Docket Nos.: 50-327/328

SUBJECT: ATWS PROCEDURES FOR SEQUOYAH

REVIEW OF ATWS PROCEDURES FOR SEQUOYAH PLANT

Figure 1. Generalized Approach to be followed for writing ATWS procedure(s)

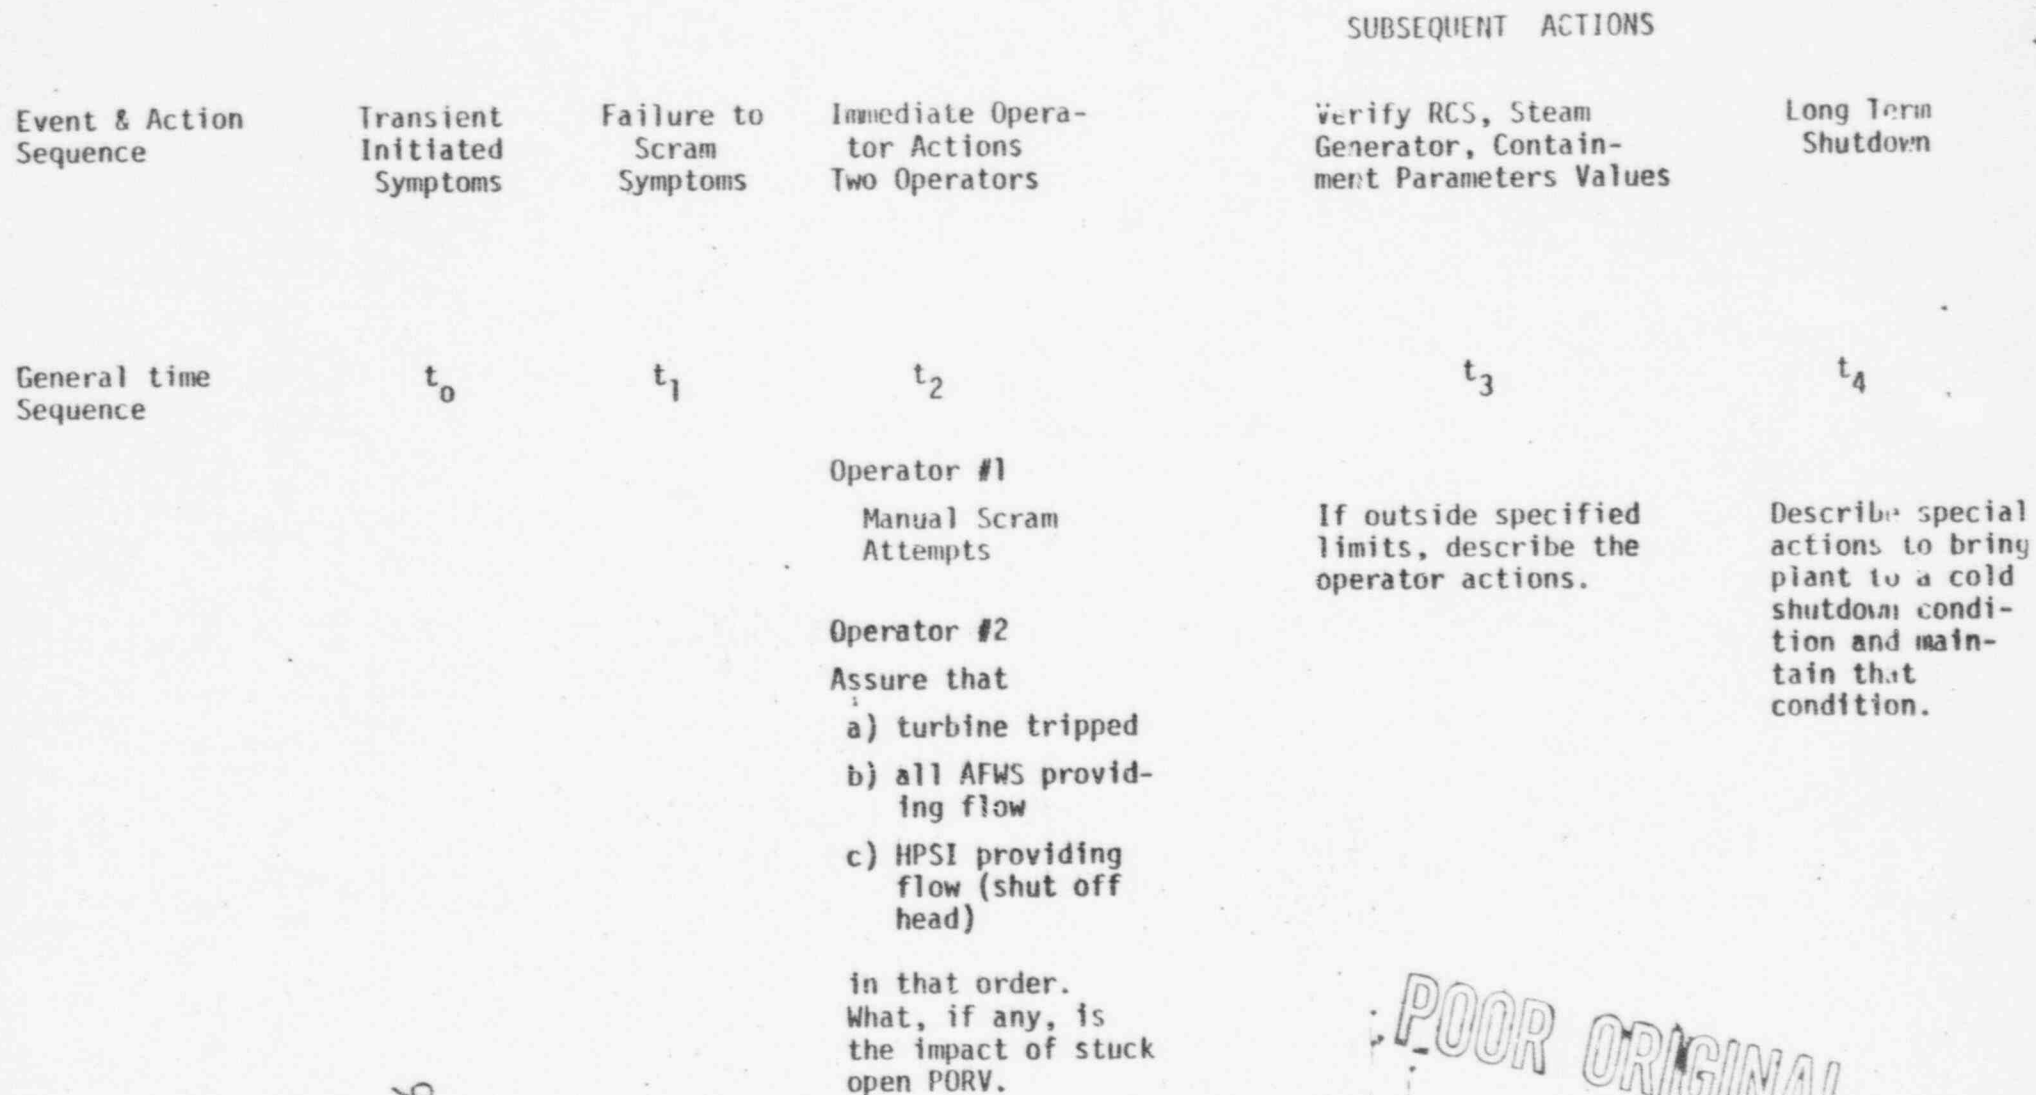
2. The immediate actions that the operators have to take after ATWS has occurred and an attempt to manually scram the reactor from the control room has failed should follow two parallel paths. While one operator should continue the operation of manually scrambling the reactor by tripping the breakers powering the control rod drive MG sets, the other operator should initiate the other actions leading to safe shutdown of the plant. The procedure should reflect that the actions described in sections A.2.b and A.2.c and those described in sections B.1 and B.2 are to be performed simultaneously. Section B should require sequential actuation of turbine trip, all auxiliary feedwater pumps, and high pressure safety injection system. (See Figure 1).
